Access Compliance Report

Public Rights-of-Way

(Curb Ramps)

Intersection ID: 12082	Main Street: ALLEN_ST	Cross Street: E_16TH_ST	Location: S
ADA ID: FA8E176984B0	Ramp Type: BlendTrans1	Initial Pass/Fail: Fail	Overall Compliance: No
			Severity Score: 18.75

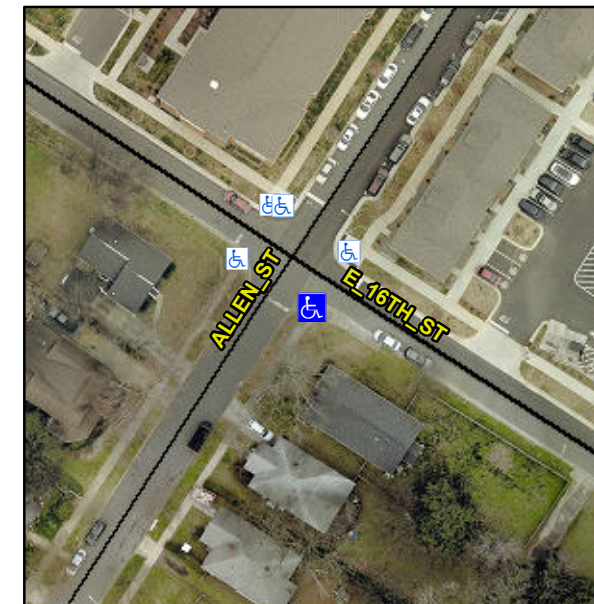
R304.5.1, R304.5.3

Compliance	Description	Data	Compliance	Description	Data
N/A	Ramp Length (in)	82.5	Yes	BlendTrans Slope (%)	0.4
No	Ramp Width (in)	32.0	No	BlendTrans XSlope (%)	4.8
N/A	Flare Type LT	N/A	N/A	Flare Type RT	N/A
N/A	Flare Slope LT (%)	N/A	N/A	Flare Slope RT (%)	N/A
N/A	Flare Traversable LT?	N/A	N/A	Flare Traversable RT?	N/A
N/A	Landing Length (in)	N/A	N/A	DWS Provided?	N/A
N/A	Landing Width (in)	N/A	N/A	DWS Contrast?	N/A
N/A	Landing Slope (%)	N/A	N/A	DWS Length (in)	N/A
N/A	Landing X Slope (%)	N/A	N/A	DWS Full Width?	N/A
N/A	Landing Curb? (Y/N)	N/A	N/A	DWS Offset (in)	N/A
N/A	Shared Landing?	N/A			
N/A	Gutter Ponding?	N/A	N/A	Gutter Slope (%)	N/A
N/A	Gutter Lip Ht (in)	N/A	N/A	Gutter X Slope (%)	N/A
N/A	Painted X Walk1?	No	N/A	Painted X Walk2?	No
	X Walk 1 Direction	To NE		X Walk 2 Direction	To NW
	X Walk 1 Width (in)	N/A		X Walk 2 Width (in)	N/A
	X Walk 1 Slope (%)	7.3		X Walk 2 Slope (%)	0.4
	X Walk 1 X Slope (%)	0.4		X Walk 2 X Slope (%)	7.1

Remove & Replace Curb Ramp With Two New Directional Ramps or Equivalent.
